National

Service Bulletin FSN-30

Subject: NC-300 Changes

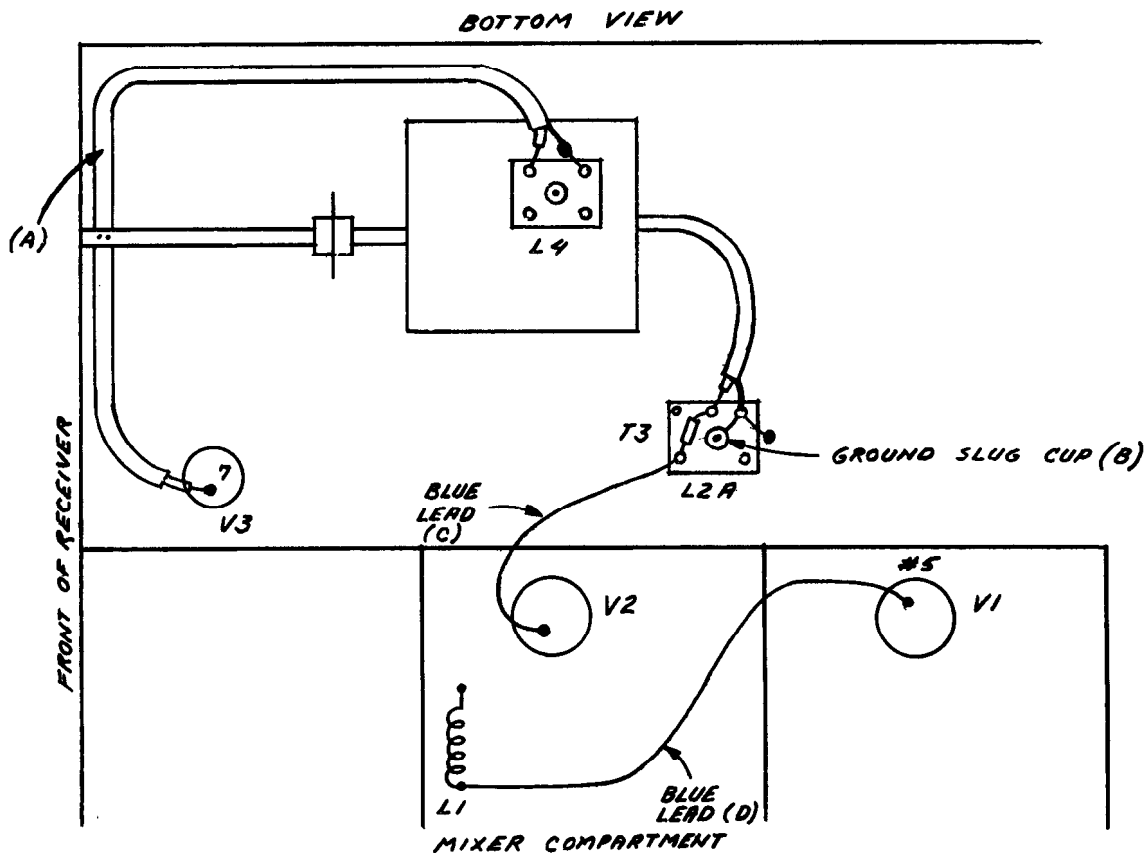
A shielded lead should be constructed as shown below:

- A. Replace shielded lead from L4 to grid of second converter, V3 with above lead, placing it under phasing control shaft as shown in the pictorial diagram below.

SUBJECT: NC-300 C6 Changes

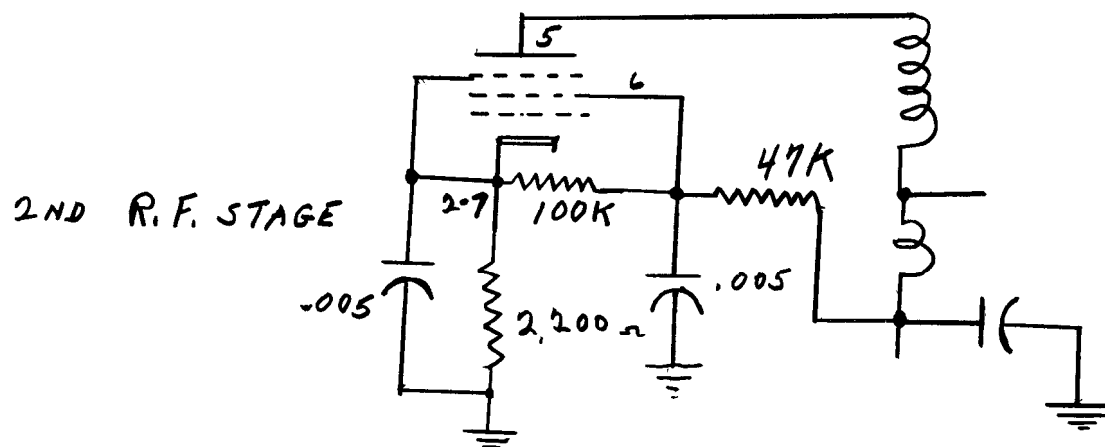
The following changes are recommended in the 6-meter converter to reduce cross-modulation:

Change cathode resistor in 6AK5 2nd R.F. amplifier stage from 470 ohms $\frac{1}{2}$ watt to 2200 ohms $\frac{1}{2}$ watt

A 100,000 ohm $\frac{1}{2}$ watt resistor should be connected between Pin #6 and Pin #2 - 7 of the same 6AK5 2nd R.F. stage

Revised circuit below:

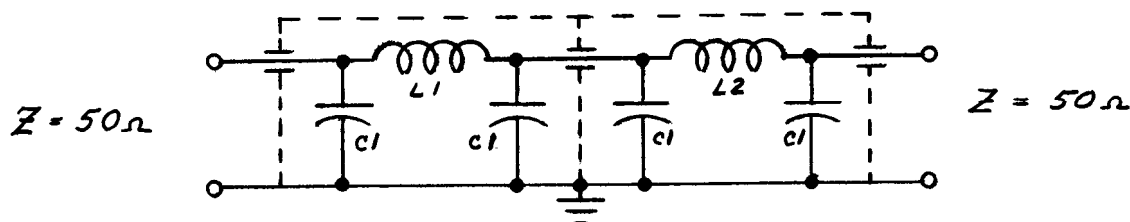
In certain metropolitan areas, I.T.V. is experienced on the 21 mc, 28 mc and X bands of the NC-300. This can be minimized by proper selection of antenna and the use of a low pass filter shown in the diagram below. This filter should be inserted in series with the antenna and located as close as practicable to the antenna terminals on the back of the chassis. A good earth ground helps considerably.

L_1 = .4 uh 10 Turns #20 on 3/8" form spaced 1/2"

C_1 = 80 uuf Ceramic

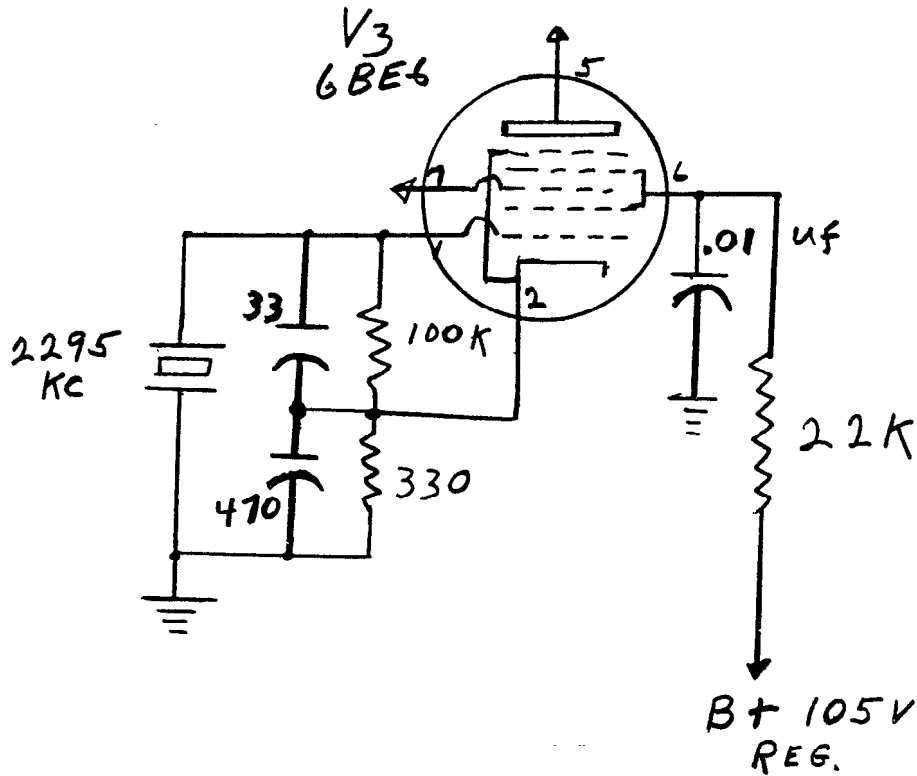
In these instances we recommend crystal control of the second conversion oscillator as per the attached schematic. It should be remembered that there are now two crystals in the circuit which must be properly coordinated if the receiver is to work at maximum efficiency. Normal production tolerances in the grinding of the crystals may allow a situation to exist where the difference in frequency of the crystal in the crystal filter (2215 kc) and the crystal in the second conversion oscillator (2295 kc) is not exactly 80 kc (second IF).

Fig. 1—Crystal controlled second converter.

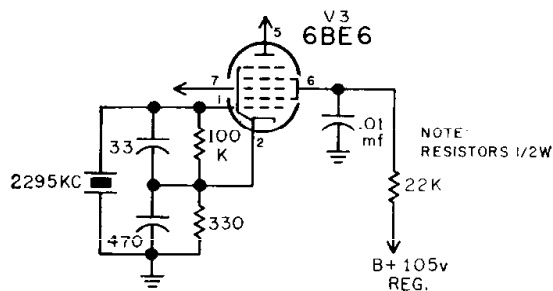
It is a simple matter to crystal control the second converter oscillator which effectively eliminates these problems.

The crystal and its associated components may be mounted in the shield can which formerly housed L6 the second conversion oscillator coil.

Fig. 2—Two new components improves audio.

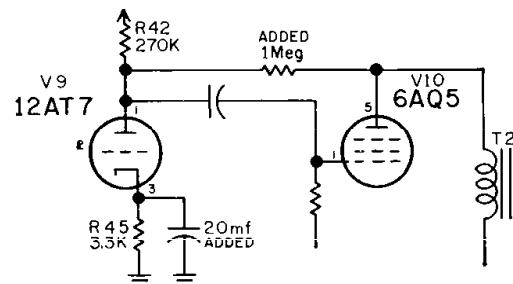
An audio change that will improve the phone quality is shown in fig. 2. It consists of a 1 megohm resistor connected between the plate of the output tube and the plate of the preceding audio stage. This has a tendency to drop the audio level which can be restored by bypassing the cathode of V9, R45 with a 20 mf. 50 volt capacitor to chassis ground.
